SUBJECT: DOE-NRC TECHNICAL MEETING SUMMARY

Enclosed is a summary of the DOE-NRC meeting held in San Francisco, California on October 16-18, 1984 at the office of Woodward-Clyde Consultants. The meeting was a review of geophysical data for the Paradox Basin.

NRC DATA REVIEW OF GEOPHYSICAL DATA FOR THE PARADOX BASIN  
16 to 18 October, 1984  
Woodward-Clyde Consultant office  
San Francisco, CA

### GEOLOGY-GEOPHYSICAL DATA REVIEW CHECKLIST

SEFEL GEOPHYSICAL  
SEISMIC DATA PROCESSING  
DENVER COLORADO

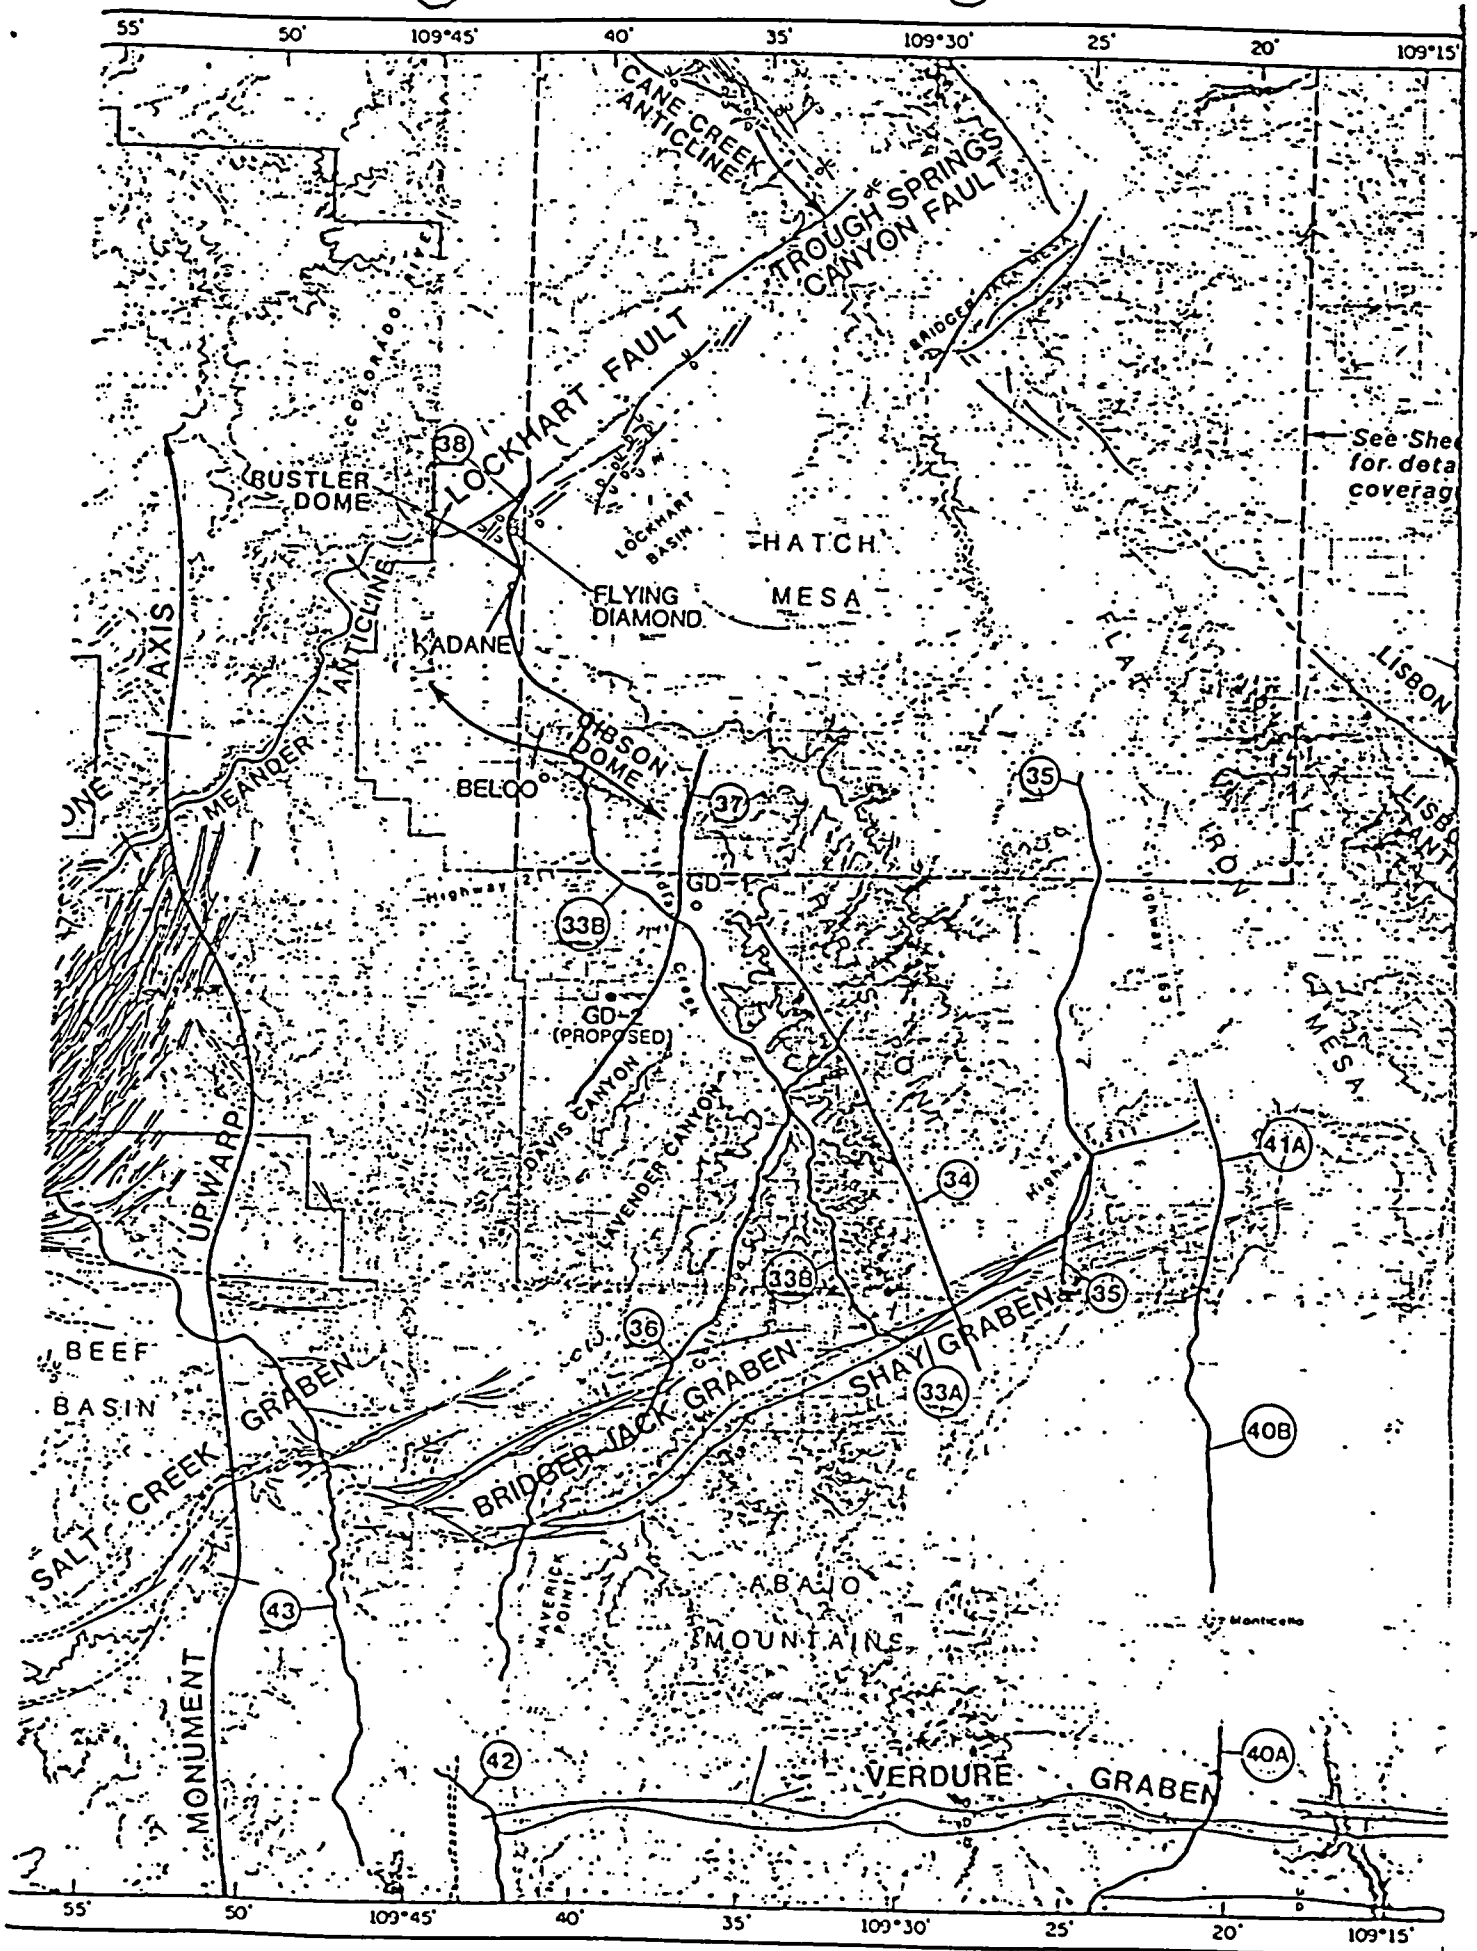
*NORMAL DATA PROCESSING USED. SEE ATTACHED HEADER SHEET  
EXAMPLE FROM LINE 37 DAVIS CANYON AREA.*
